2211 SW 4TH

DESIGN REVIEW SUBMITTAL

revised July 21, 2016

**PREVIOUS CONCEPT PLAN
PRE-APPLICATION [EA 15-114048]
DESIGN ADVICE REQUEST [15-153663]**

① Level 1 RCP
1/16" = 1'-0"

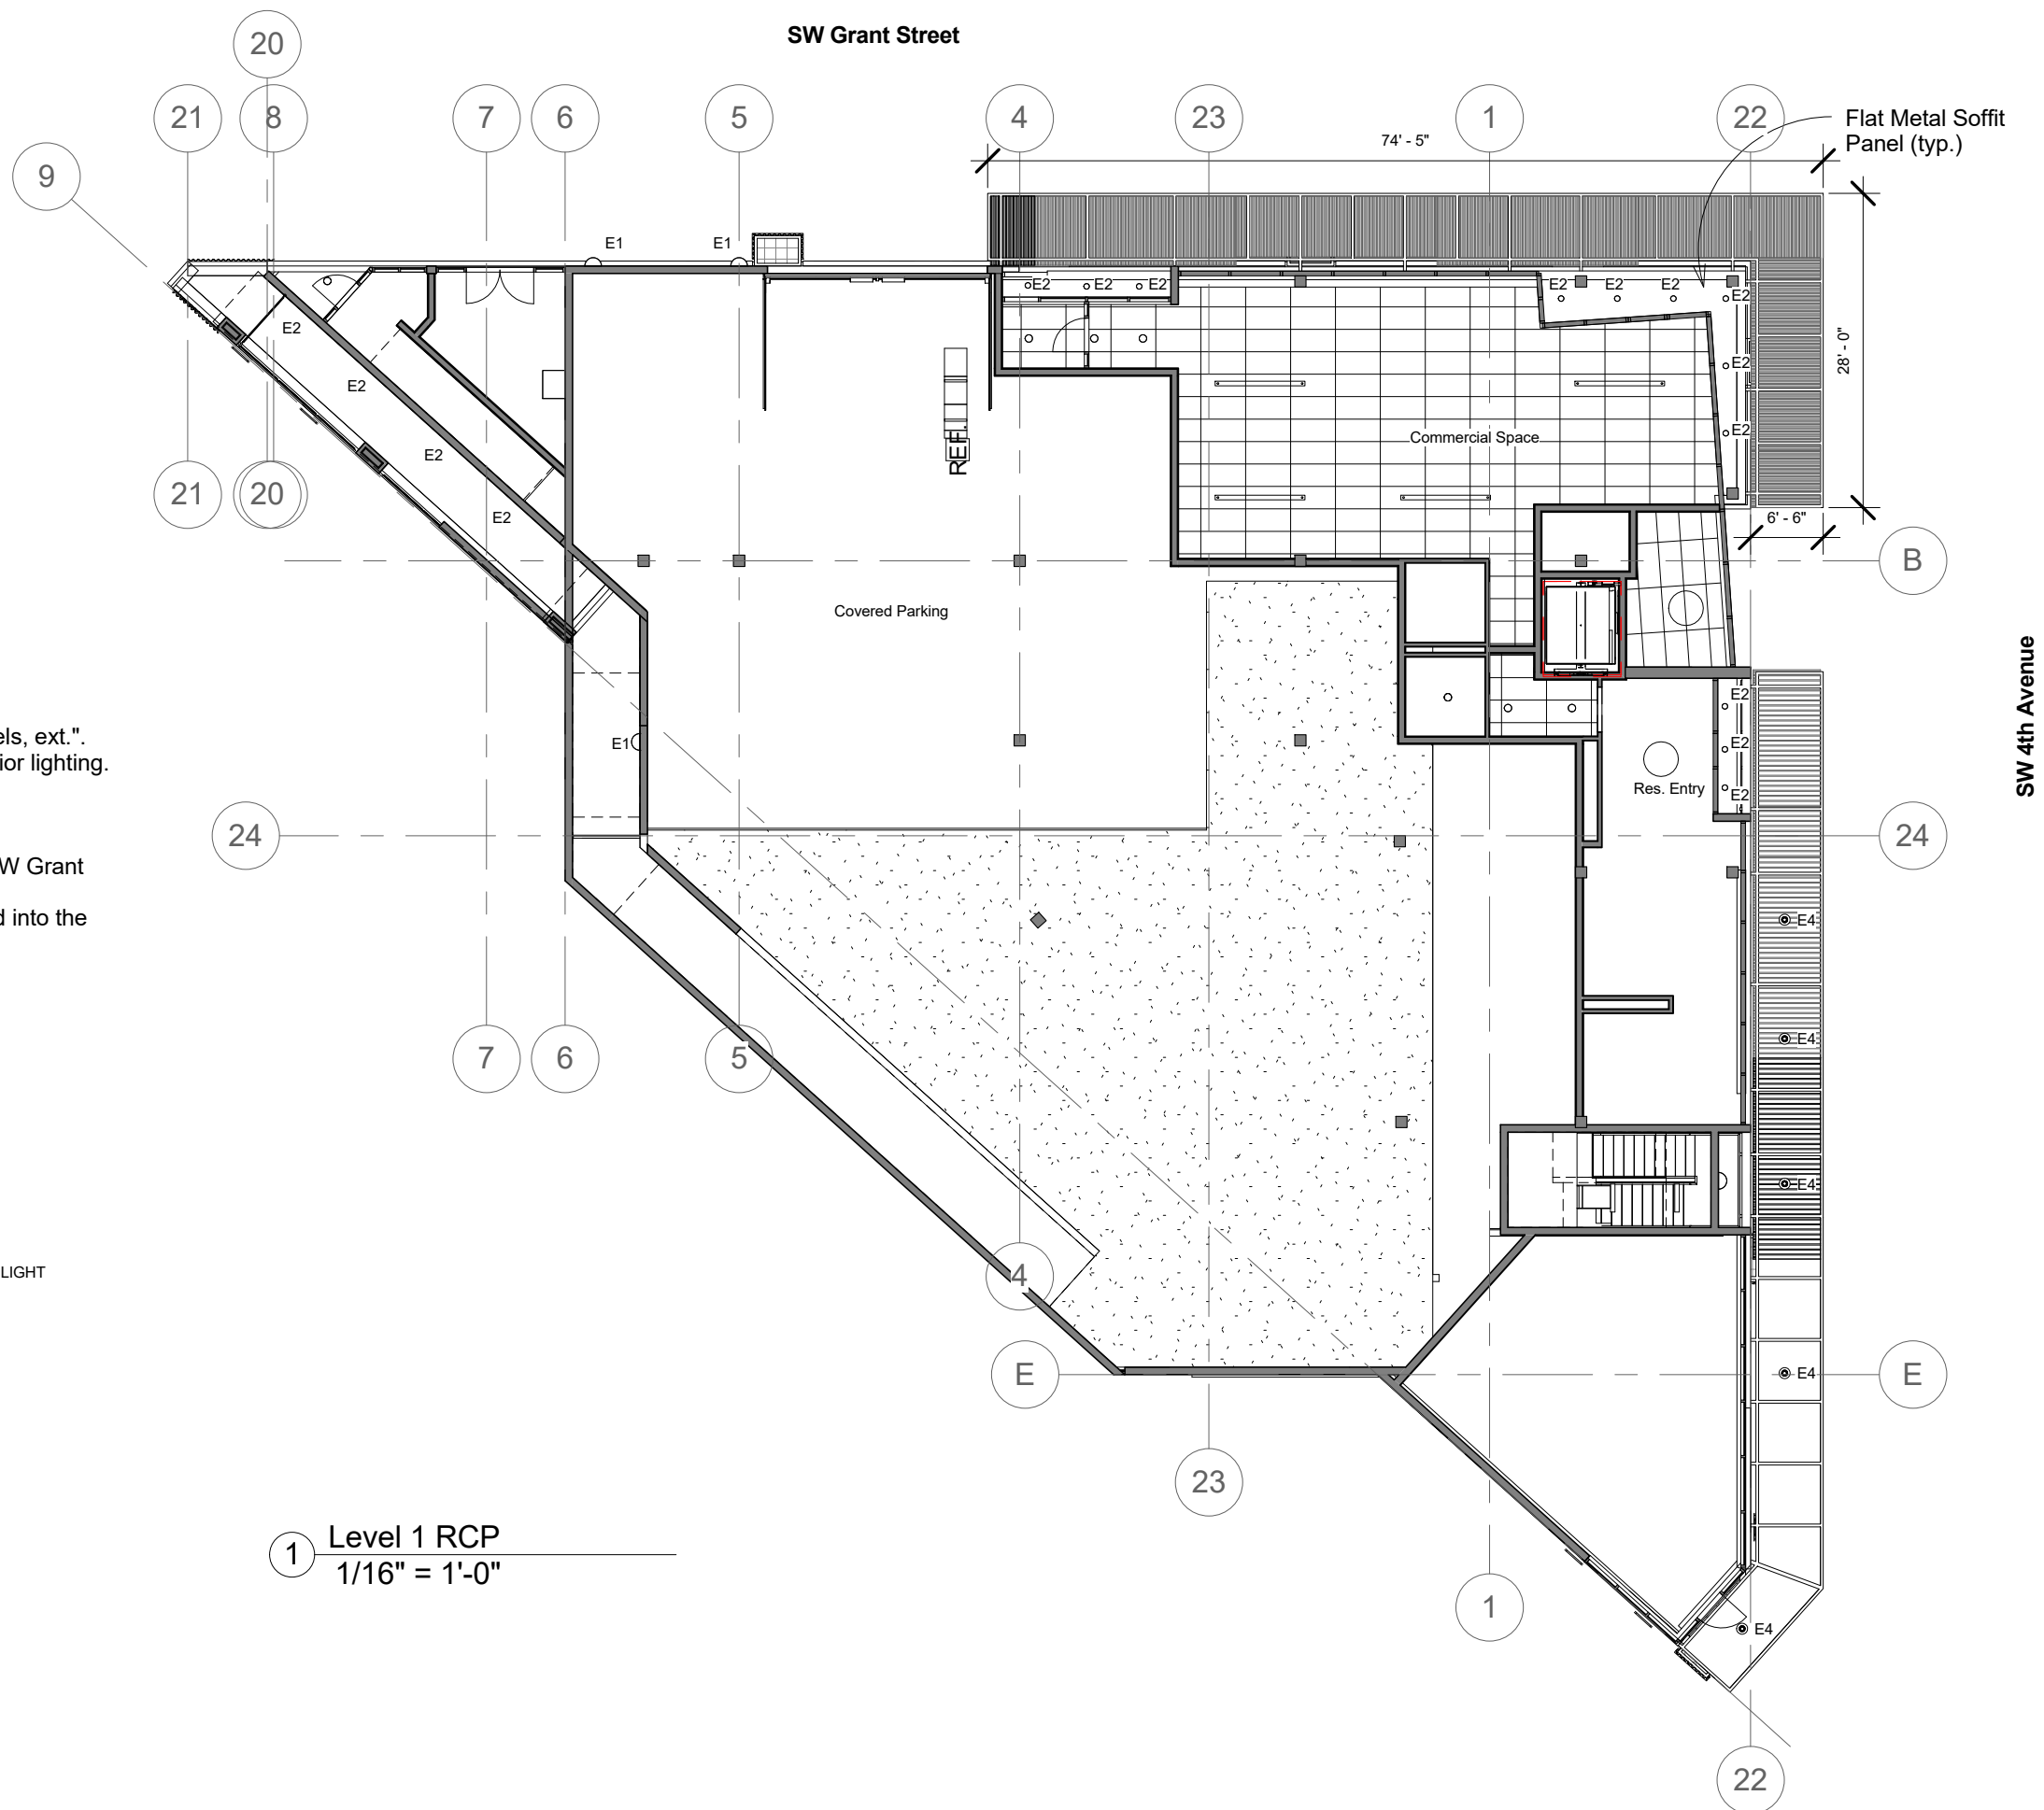
- Comments:
- 1.) Provide canopies and weather protection at "entrances, oriels, ext."
 - 2.) No exterior lighting is shown in drawing set - integrate exterior lighting.

- Summary of changes:
- 1.) Canopies have been provided along SW 4th Avenue and SW Grant Street.
 - 2.) Exterior lighting has been added to the plans and integrated into the building design.

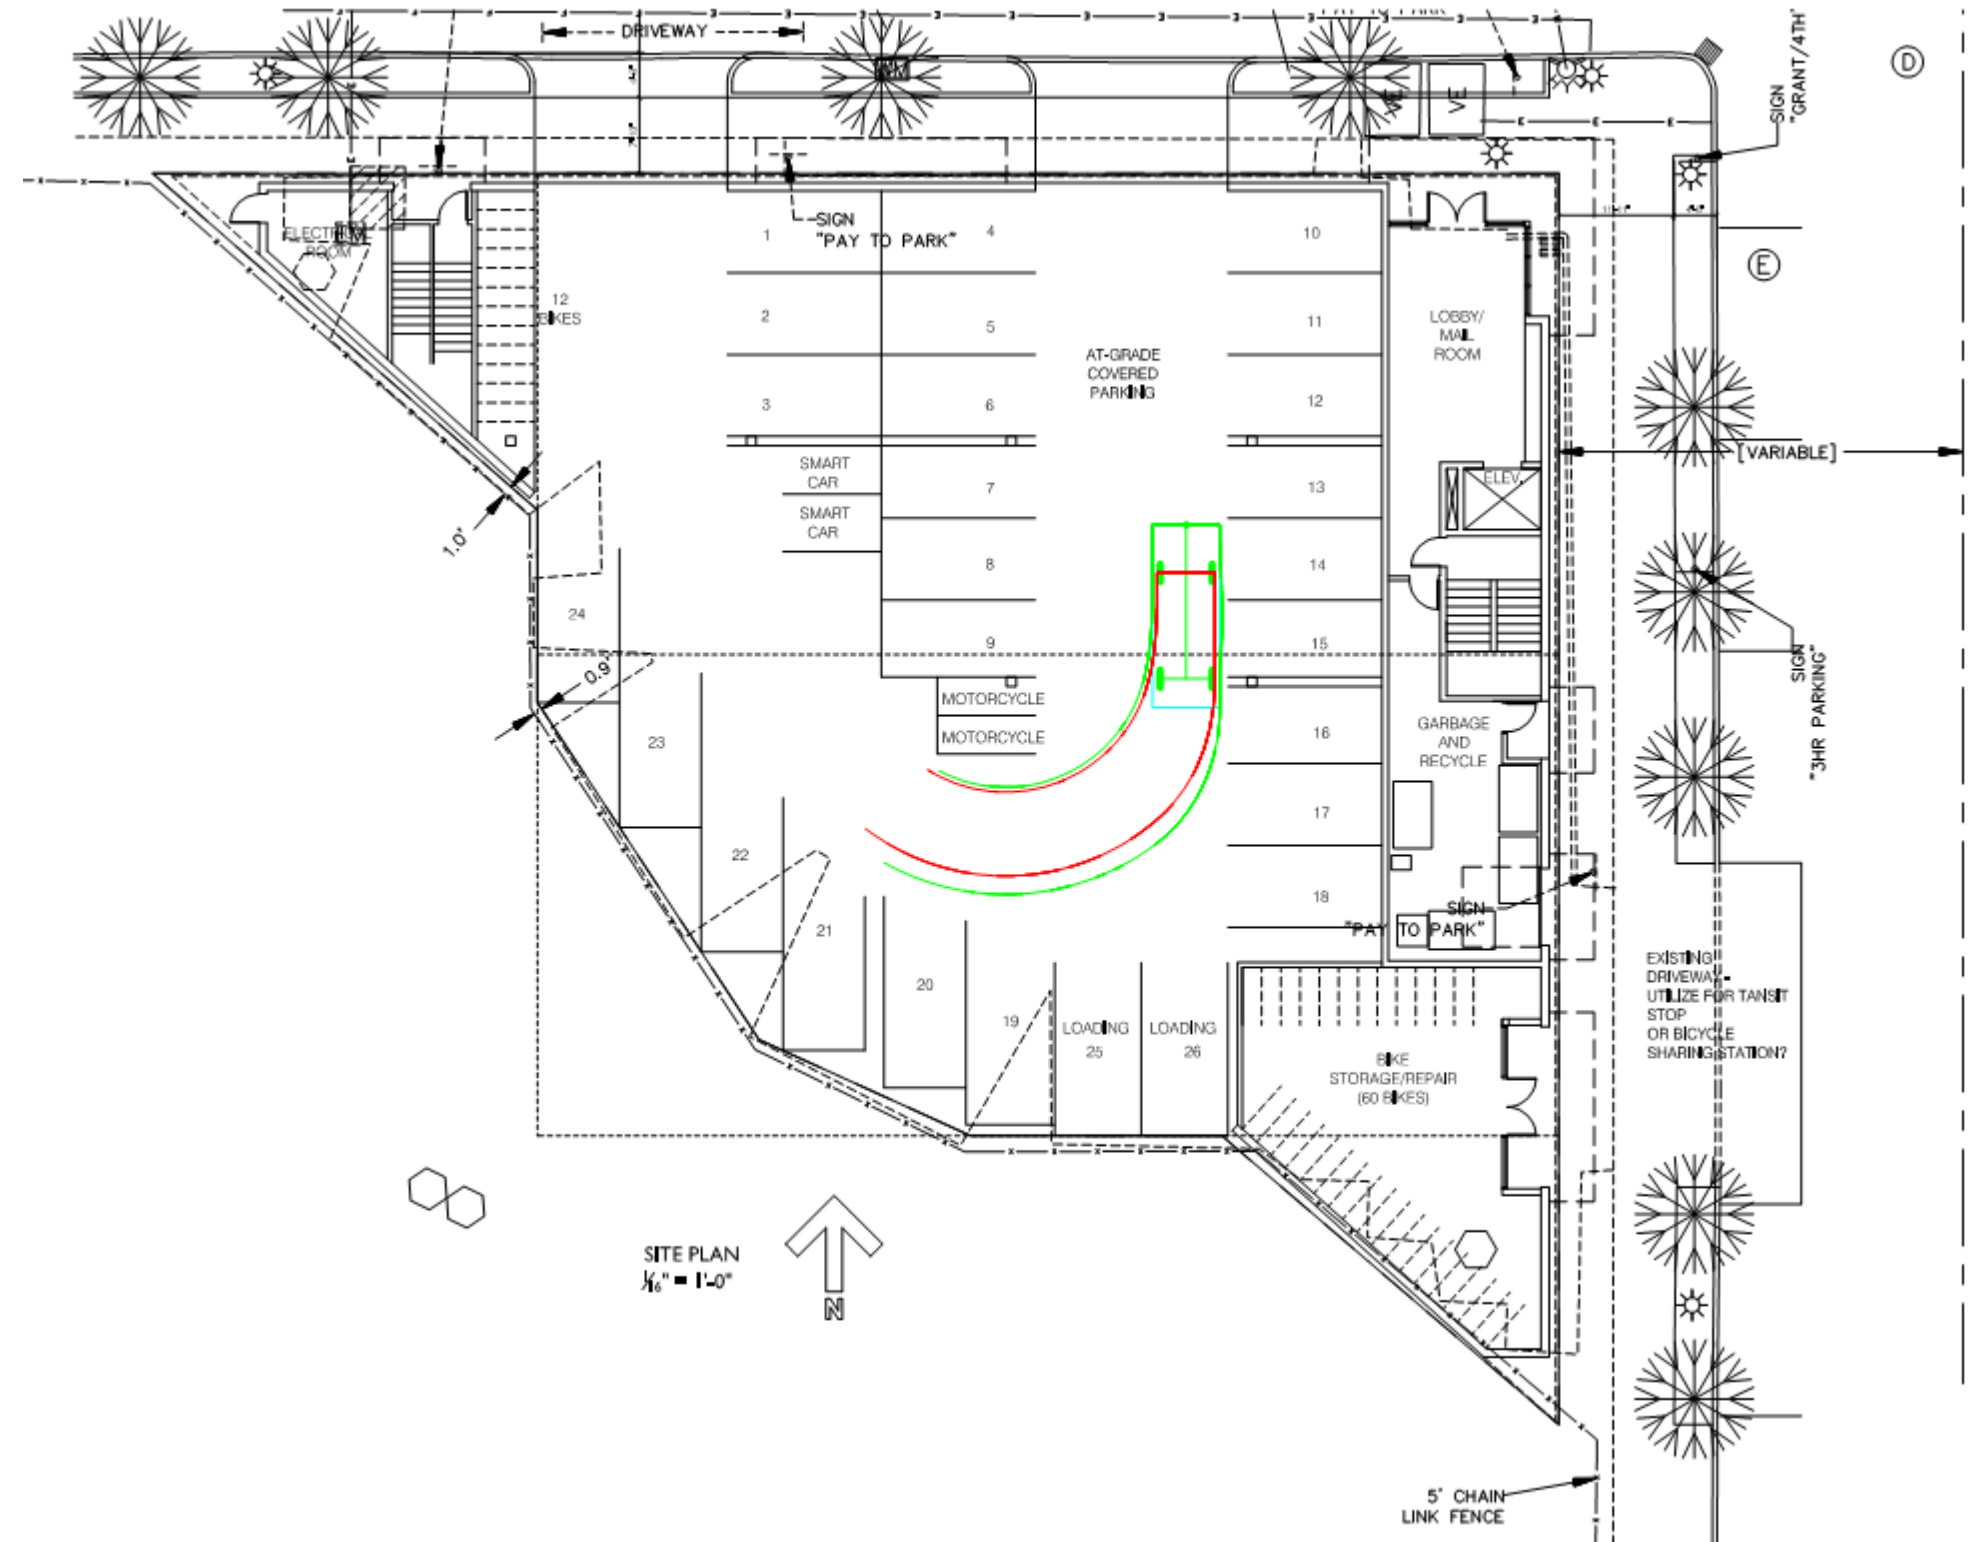
- 1.) Garage access: Queuing for cars out of the parking garage requires the gate to be located 20' from the sidewalk.
- 2.) Vault location.
- 3.) Loading zone requirements, type A or B

- 1.) The parking garage gate is not intended for daily use, and would remain in the open position while the parking area is in use. The use of a gate would be to provide security when the parking area is closed. A warning system is planned for the single entry/exit.
- 2.) Utility vaults serving the project are planned to be located at grade within the covered parking area. In the event a utility vault cannot be located or relocated onto the site, the vault shall be located within the 4' furnishing zone per city standards.
- 3.) Loading and unloading is proposed to be located within the covered parking area, loading activities would either temporarily utilize the on-site parking or use the drive isle as needed. A standard B loading zone 18' long, 9' deep and 10' high would fit in the proposed parking garage.

PREVIOUS APPLICATION ELEVATION

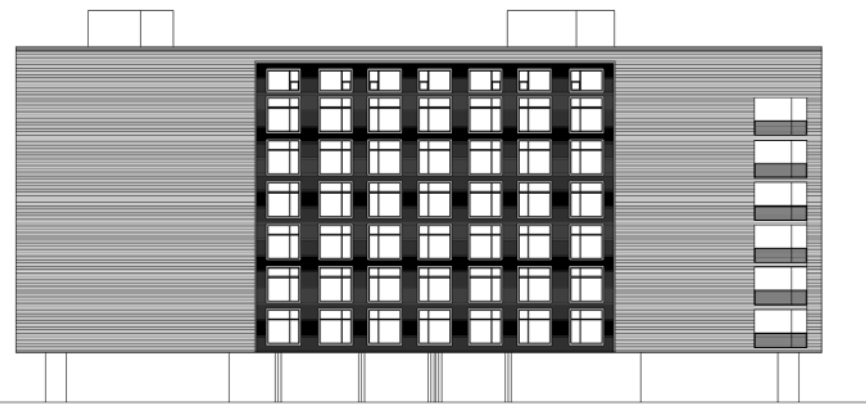
- 1.) Massing Scale and Form - reduction in bulk.
- 2.) Materials: Suggestion to explore masonry based material to replace the metal as a primary cladding system.
- 3.) Rain Garden Planter on Building Wall.
- 4.) Ground level board form design - Better detailing is required.
- 5.) Vents and Louvers. Not clear how these are handled.
- 6.) Missing pedestrian amenities.
- 7.) Active corners.

- 1.) Revised shape of building to reduce building mass, shifts in material and facade help to reduce mass.
- 2.) The metal siding has been exchanged with masonry brick to become the primary cladding material, while the vertical ribbed metal becomes the accent material.

- 6.) Canopies, seating, and site amenities have been added and thoughtfully placed in a rhythm that compliments the architecture within the overall facade and at the pedestrian level.

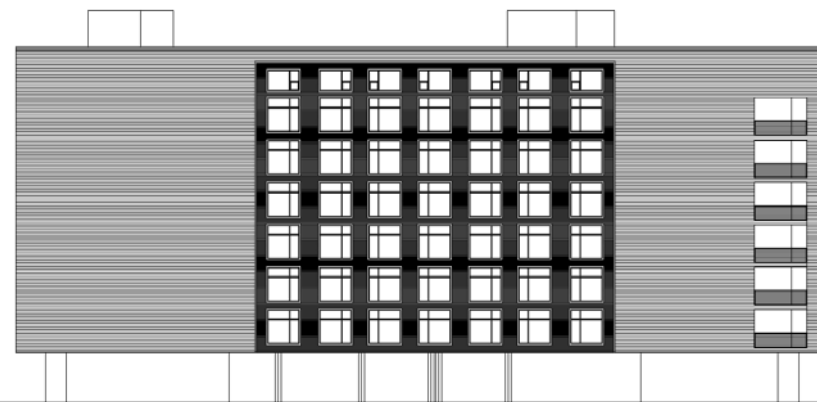
- 1.) Massing Scale and Form - reduction in bulk.
- 2.) Materials: Suggestion to explore masonry based material to replace the metal as a primary cladding system.
- 3.) Vents and Louvers. Not clear how these are handled.
- 4.) South elevation treated like "back of house".

- 1.) Revised shape of building to reduce building mass, shifts in material and facade help to reduce mass.
- 2.) The metal siding has been exchanged with masonry brick to become the
- 3.) All vents and louvers for the residential floors are to be terminated through the roof to minimize penetrations in the facade. The exception to this rule would be free air vents within the VPI vinyl windows which would be integrated into the window and have very low visibility. Grade level vents and louvers are to be located in the spandrel glazing above the canopy and at the pedestrian level.
- 4.) The South and West elevations, facing I-405, have been redesigned to provide more interest and architectural features. The shape of the building responds to its triangular site and has been optimized to reduce the overall mass from the former design.
